# Access Compliance Report

## Public Rights-of-Way

### (Curb Ramps)

| Intersection ID: 10036931 | Main Street: S_SHARON_AMITY_RD | Cross Street: N/A       | Location: NW           |

| ADA ID: E6166467747B      | Ramp Type: PerpDiag            | Initial Pass/Fail: Fail | Overall Compliance: No |

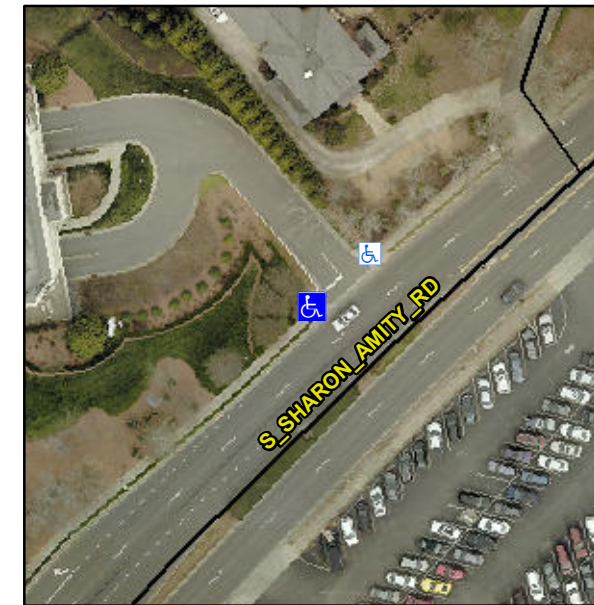
**Not Found, R304.5.3**

| Compliance | Description           | Data  | Compliance | Description                 | Data  |
|------------|-----------------------|-------|------------|-----------------------------|-------|
| Yes        | Ramp Width (in)       | 48.0  | No         | Ramp XSlope (%)             | 5.3   |

**Remove & Replace Curb Ramp With Two New Directional Ramps or Equivalent.**
